**Comments on the Portland Harbor Feasibility Study
By Environmental Stewardship Concepts, LLC
For the Willamette Riverkeeper and the Portland Harbor CAG
July 27, 2012**

Figure 1. Minimum, mean, and maximum monthly Willamette River stage at Portland, Oregon from years 1973 through 2003. (US Army Corps of Engineers).

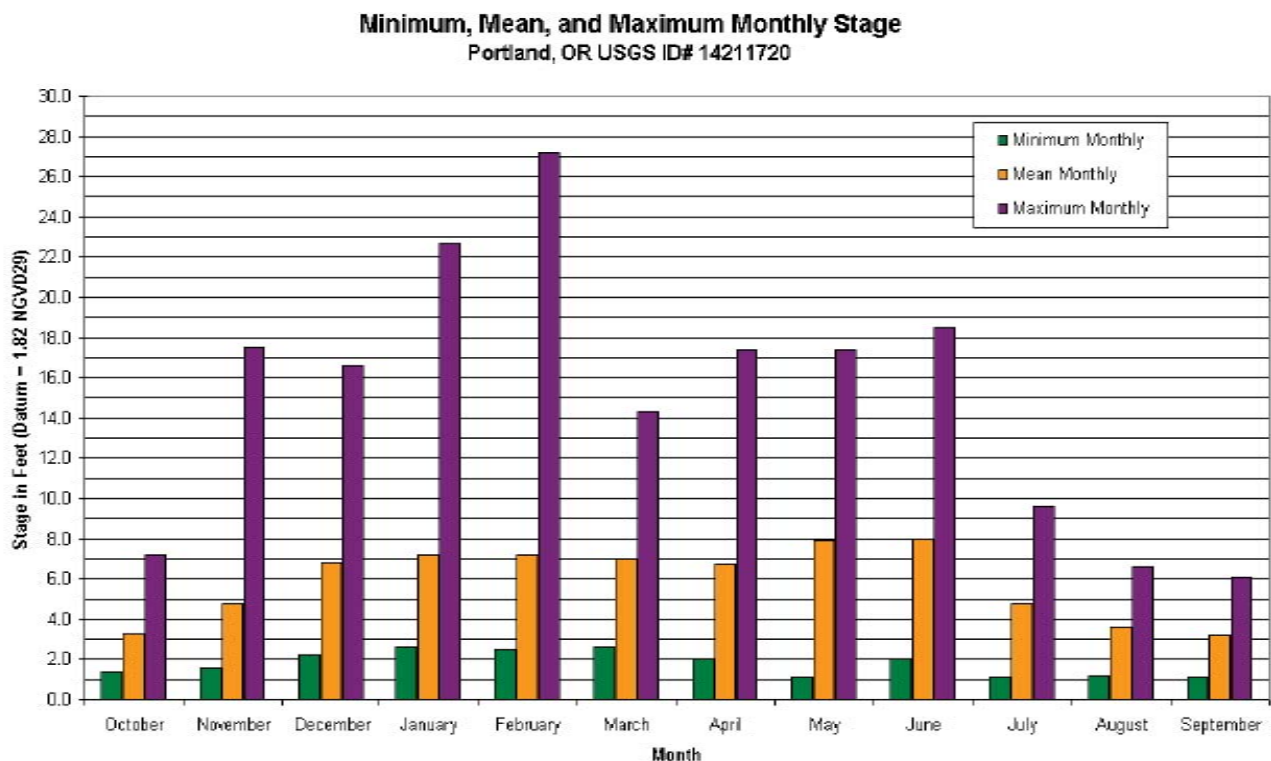
2. **Section 2.1.1** (Hydrology) states that, “River stage and currents at the Site are influenced by hydrologic conditions in both the Willamette and Columbia Rivers, and are further affected by the operations of federal and non-federal dams along these two rivers, as well as tidal stages of the Pacific Ocean, which causes tidal fluctuations of up to a maximum of 3 feet per day throughout the Site.”

Relative to the tide difference, there is more than a 3 foot tidal fluctuation. Is the three feet only referencing the influence of the ocean tides on the fluctuations seen at Portland Harbor? USGS tides recorded at Morris Street Bridge show that an average tidal fluctuation in a day would not likely average to 3 feet.

Figure 2. Willamette River stage at Portland Oregon, from October 1, 1988 to June 8, 2012 (USGS)

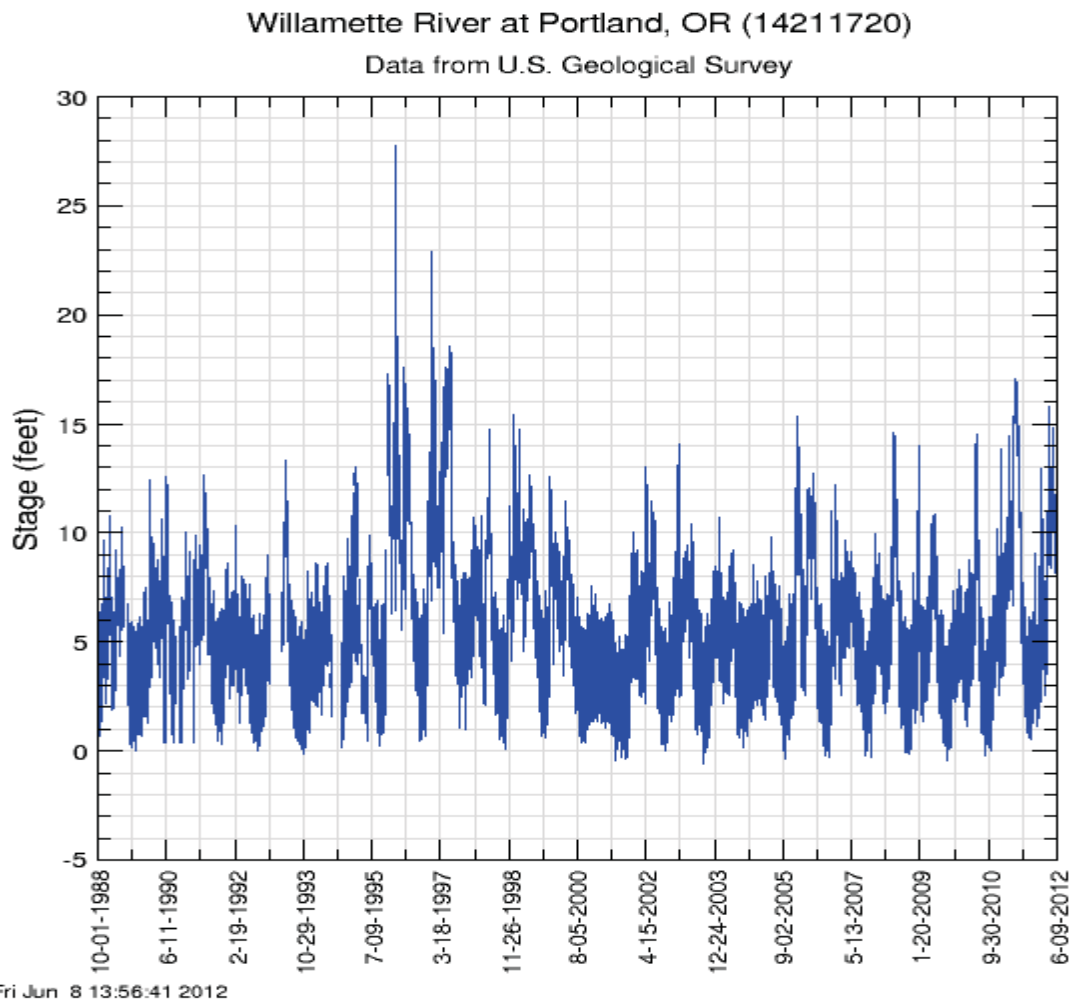
3. **Section 2.1.1** references past extreme flood events: “The two highest peaks in the daily mean discharge record occurred during the winters of 1996 and 1997, when peak flows reached 420,000 cfs on February 9, 1996 and 293,000 cfs on January 2, 1997, respectively... As discussed in the draft final RI, unlike the Columbia River, the Willamette River flows generally increase in response to

regional storms due to the comparatively small size of the basin. Record winter floods (e.g., 1964 and 1996) occurred when periods of heavy snowfall at lower elevations were followed by warming periods and heavy rains, resulting in rapid increases in runoff.”

Have the alternatives been examined under conditions **more extreme** than these flood events? Any models using flow and river stage should incorporate the increasing occurrence and frequency of these events, as they are more likely a result of global warming. The following graph shows the Willamette River stage at Portland Oregon and the floods of 1996 and 1997.
